E8357A-02E

S E R V I C E N O T E

E8357A PNA Series RF Network Analyzers

Serial Numbers: 00000000 thru 46999999

Figure 1

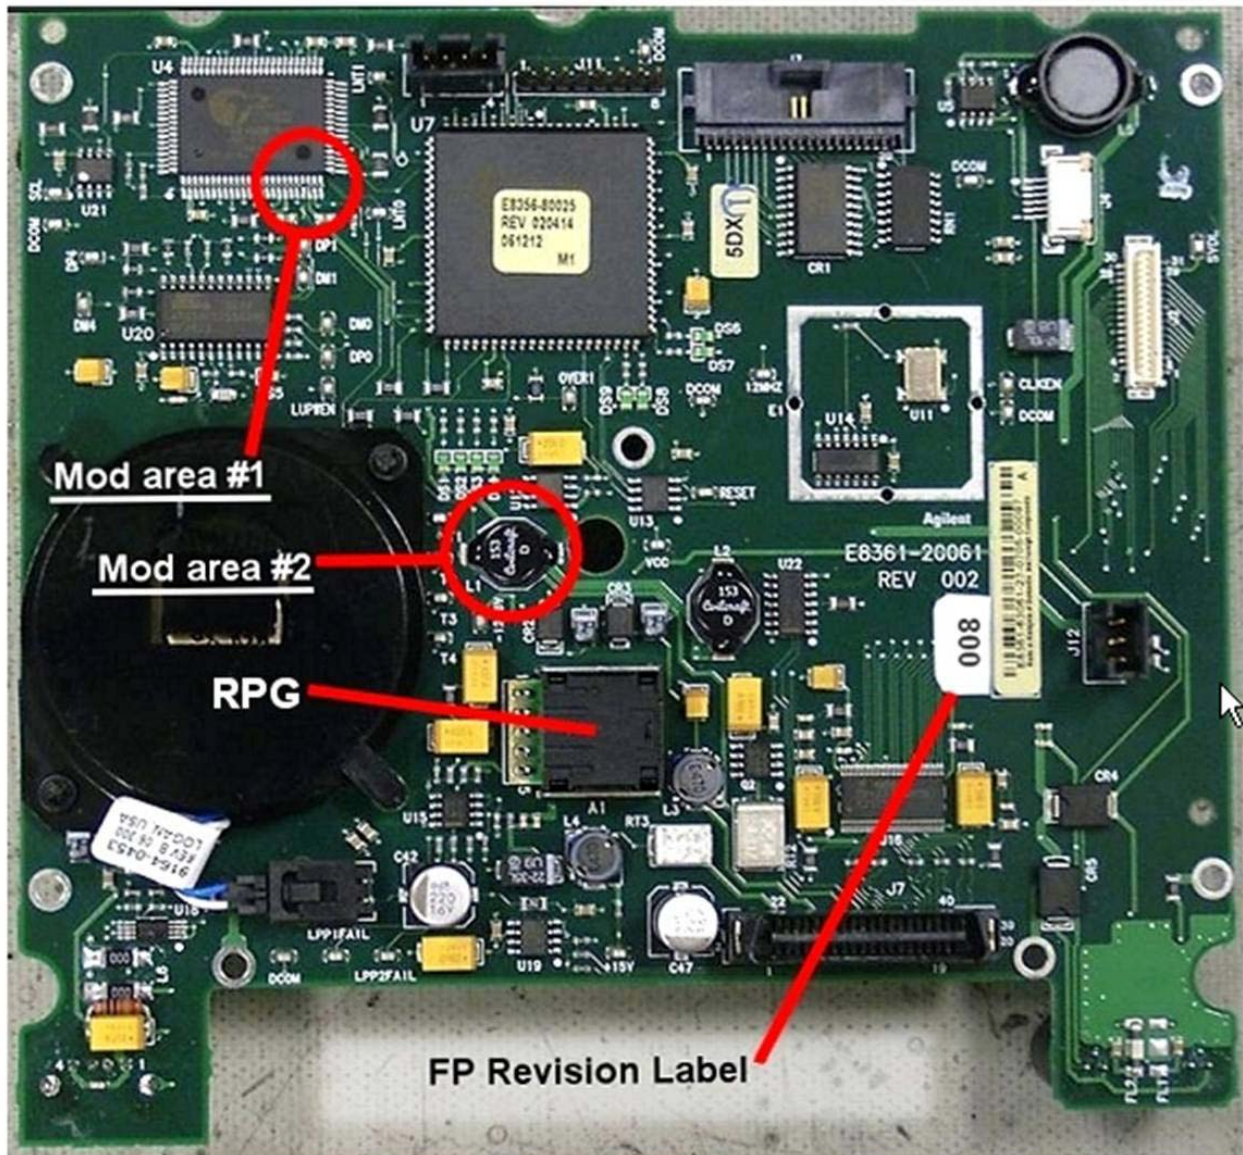
Refer to Figure 1 for the two modification areas to be addressed. Note that while this picture happens to show the FPI board completely removed from the front frame assembly, this is not necessary to perform the required modifications.

- Modification #1 consists of shorting two pins of U4 together with a small amount of solder.
- Modification #2 consist of removing L1.

Figure 2

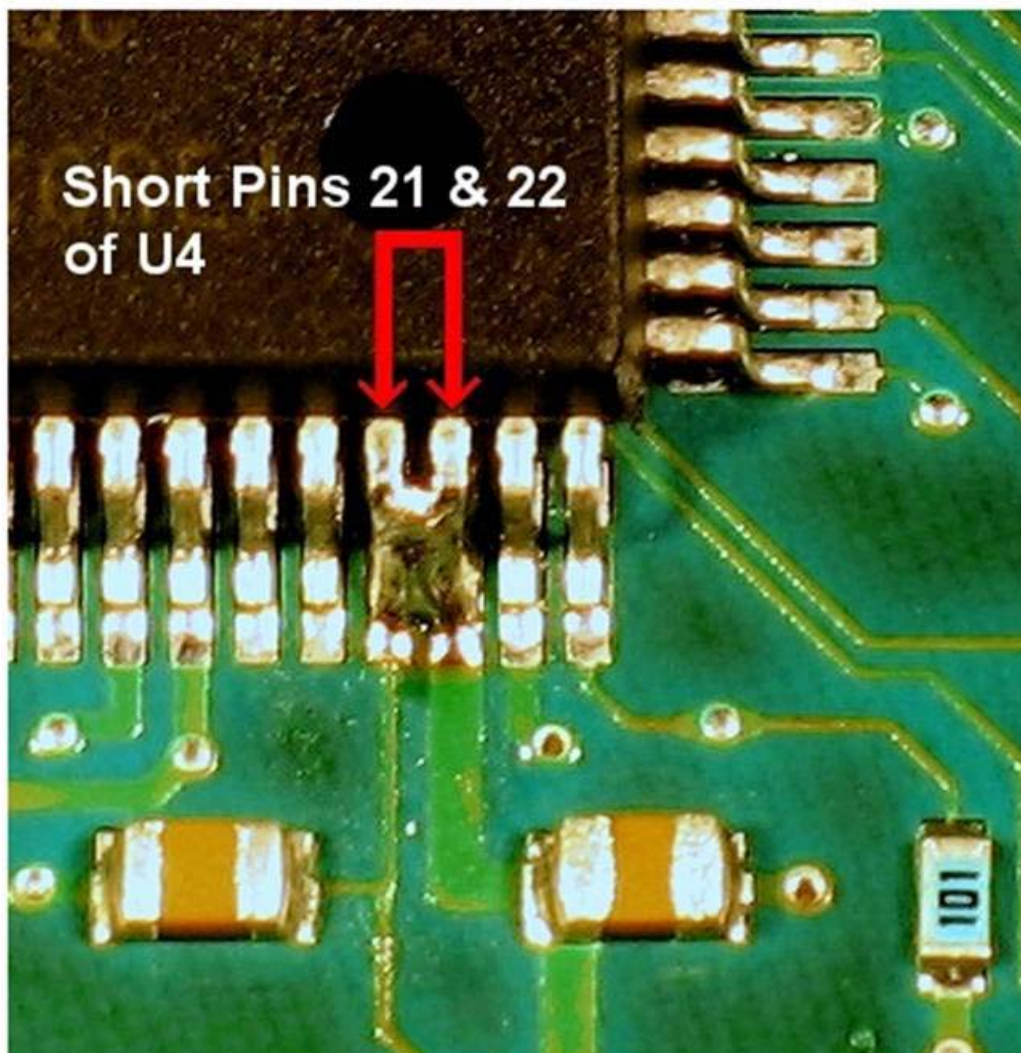
Carefully solder pins 21 and 22 together on U4. Refer to Figure 2 for the exact location. Use care so that no other pins are shorted. Use of a very fine tip soldering iron is recommended and a large work-task magnifying glass is very helpful.

Unsolder and completely remove the black surface mount inductor L1 from the front panel assembly board. This is no longer needed and can be discarded.
